TECHNICAL MEMORANDUM

Project No. 20446521-003-TM-Rev0-6000

DOMES DESIGN ISSUED FOR CONSTRUCTION DRAWINGS

PROJECT
WASTE ROCK DOME DESIGN
LUPIN MINE CLOSURE
NUNAVUT, CANADA

TITLE
PROPOSED WASTE ROCK DOME

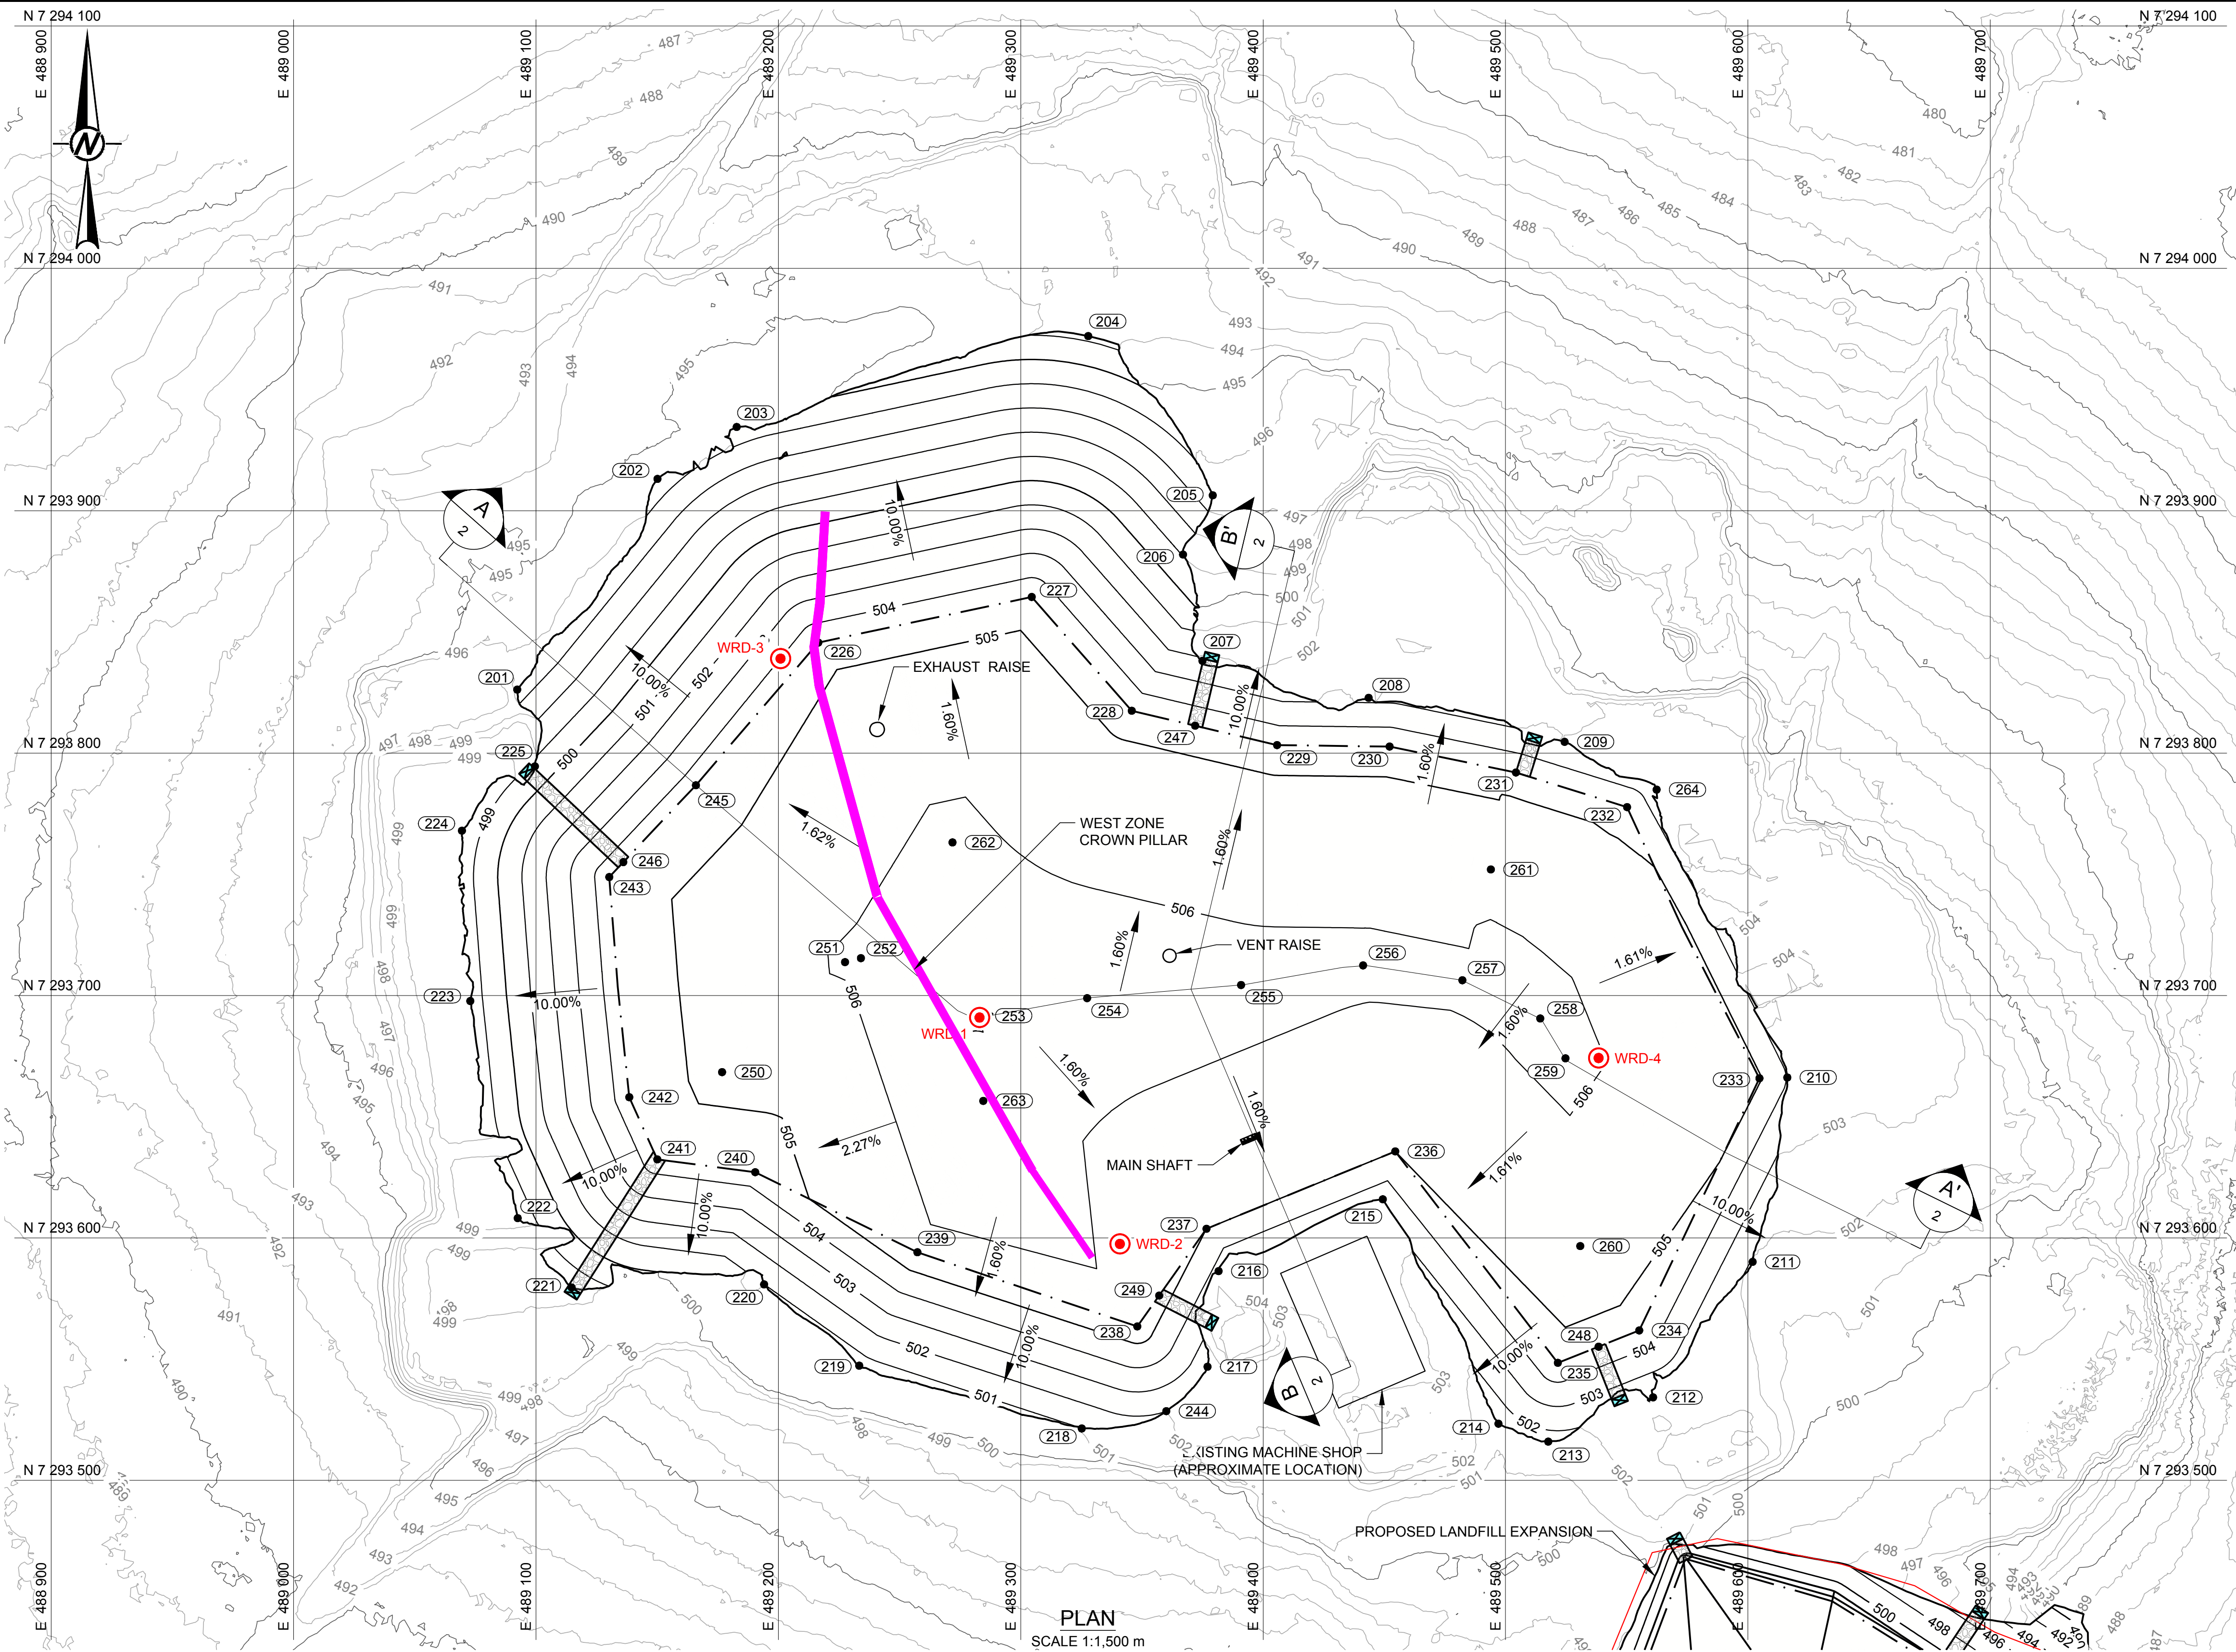
- a. lack of detailed grading information for top of "dome";

- c. no protection against rill erosion on long 10% slope surfaces;

- f. lack of specific notes to address construction constraints that need to be addressed before cover can be placed;

h. failure to show locations of shaft, crown pillar area, that will be buried under the dome.

Our review of the plans and sections observed that the 10% slopes, about 300m of top edge in the north portion of the “dome” is as much as 10m high and this extends out about 100m to the toe. The west and southwest side of the dome has a height of between 5m and 6m and thus extends out some 50+/- meters in these areas. Other than indicating that a berm will be constructed on the top edge of the dome to direct “dome surface” runoff to drainage chutes, no erosion control measures are included for ensure erosion protection and stability of these long 10% esker slopes. The plans and sections indicate that surface water runoff from the 1.6% surface slope, is expected to be drained off the dome, down the 10% slopes, via 6 runoff “drainage chutes”. Surface runoff is to be directed to these “chutes” by a small perimeter berm along the edge of the dome surface (0.5m high, 0.5m crest width, 2:1 slopes) constructed with the same esker material as the 1m dome cover surface. Given the importance of this berm in preventing overland sheet flow to the 10% slopes, we question the long term stability of the berm design as presented.

No information is provided to support the designs of the top perimeter berm, the chutes, or the stilling basins. No drainage elevations are provided with respect to surface grading on the top of the dome edges, and no information is provided with respect to the drainage runoff flows leaving the “stilling basins” at the toe of the dome. No details are provided for the toe of the 10% slopes, nor for runoff from “stilling basins”, which in some locations could undercut the toe of the cover (see north central discharge). In the absence of this information, we do not have confidence that the design as shown will be stable in the long term. The proposed designs as shown reinforce our concerns that the 10% slopes will at a minimum be subject to long term rill erosion even if the upper berm controls runoff to the discharge chutes. We are concerned about the long term performance integrity of the up diversion berm if constructed as shown with esker material. We note that any failure along of the top berm would result in additional erosive forces on the 10% slopes. We are concerned that no toe stabilization / armouring measures are included to protect the toe of the 10% slope. Provide information listed in this paragraph to demonstrate how the long-term erosion stability of the designs is being ensured.

- Note 1 which states that “subgrade under the dome area is to be prepared in accordance with the Water Licence and FCRP before waste rock or cover materials are placed”.

The intent of this statement is correct, but it is not clear to us how LMI will ensure compliance with this note is achieved if it these requirements are not specifically stated on the drawings. Ensure all relevant requirements are specifically referenced.

- Drawing Note 2 provides a list of materials that are to be removed before waste rock is placed, but the drawing does not identify the locations of these materials. It is unclear how this will be achieved in the absence of specific references to the dome plan. Include location of materials to be removed before waste rock placement.

- Drawing Note 4 states that crown pillar and openings and mine shafts are to be filled before waste rock is placed on top. Provide plans shared with Inspector of Mines to obtain approvals.

Grading details for the top of the dome are provided on Dwg. 19136158-0002-CM-0001_Rev 1. The surface has been modelled in ACAD and layout points were provided for construction. As indicated in Note 7, the final elevation of the top surface will be varied to suit the actual volume of waste rock that is imported from elsewhere on the mill site; however, the design slopes of the surfaces will not be changed.

A berm and swale system will be constructed at the perimeter of the top surface to direct runoff into the six chute structures. This will prevent any runoff from the top surface from “spilling over” and running down over the 10% sideslopes. As a result, runoff from the 10% sideslopes will be limited to that generated from rainfall or meltwater from the slopes themselves. It is noted that the esker material is a well graded material that typically contains about 39% gravel. Should incipient rilling erosion occur on the sideslopes, the esker material will tend to exhibit “self-armouring”.

The former mine and mill were located at the top of a gentle hill which reflected an underlying bedrock high. The dome is a gently sloped structure centred on the top of the hill. As a result, the discharge from each chute will flow radially away from the dome, mirroring the natural drainage pattern. Note 11 on Dwg. 19136158-0002-CM-0001_Rev 1 directs the Contractor to “construct berms or ditches as necessary to direct flow from drainage chutes away from the toe of dome fill.” Such berms or ditches will be field fit to the ground surface that surrounds the dome after the waste rock is removed from the surrounding areas.

Notes 1 on Dwg. 19136158-0002-CM-0001_Rev 1 indicates that “the subgrade under the dome area is to be prepared in accordance with the water licence and the final closure and reclamation plan (FCRP) before imported

waste rock or cover materials are placed.” Note 2 indicates that “the following materials shall be removed from the existing subgrade before imported waste rock is placed: petroleum hydrocarbon contaminated soils, arsenic “hot spots”, soil or waste rock contaminated with cyanide or lead nitrate and any hazardous waste.” Cleanup of these areas is under the supervision of Golder technical staff following a protocol for field and laboratory testing that is documented in a written Soil Quality Assurance / Quality Control Plan (Lupin Mines Incorporated, 2021).

The locations of the crown pillar area and shafts has been added to Dwg. 19136158-0002-CM-0001_Rev 1 for information.

The perimeter berm alignment has been designed to provide a gentle positive gradient towards the entrances to each of the chutes. This will prevent a buildup of deep water against the inside of the perimeter berm. Given the gentle gradient, the flow velocities along the swale towards the entrances to the chutes will be low, and as discussed above the esker material is expected to self-armour. In any case the presence of erosion protection at the entrance to the chutes will prevent erosion from cutting down below the grade of the sills at the top of the chutes.

As discussed above, the discharge from each stilling basin will generally flow radially away from the dome, mirroring the natural drainage pattern. Note 11 on Dwg. 19136158-0002-CM-0001_Rev 1 directs the Contractor to “construct berms or ditches as necessary to direct flow from drainage chutes away from the toe of dome fill.” Such berms or ditches will be field fit to the actual ground surface that remains after the waste rock is removed from the areas surrounding the dome.

As discussed above, the cleanup of these areas will be under the supervision of Golder technical staff following a field and laboratory testing protocol that is documented in a written Soil Quality Assurance / Quality Control Plan (Lupin Mines Incorporated, 2021).

As discussed above, the areas where known soil contamination is present are shown on a separate drawing: Dwg. 19136158-0005-CM-0001 Rev. D.

GOLDER RESPONSE:

LMI provided the plans and approvals for the crown pillar with their responses to the NWB under Part E, Item 25 review process on October 20, 2020, and their responses to the NWB for the updated FCRP Rev 1 review process on March 19, 2021. CIRNAC advised they were satisfied on October 30, 2020, and the NWB approved the updated FCRP Rev 1 on March 26, 2021.
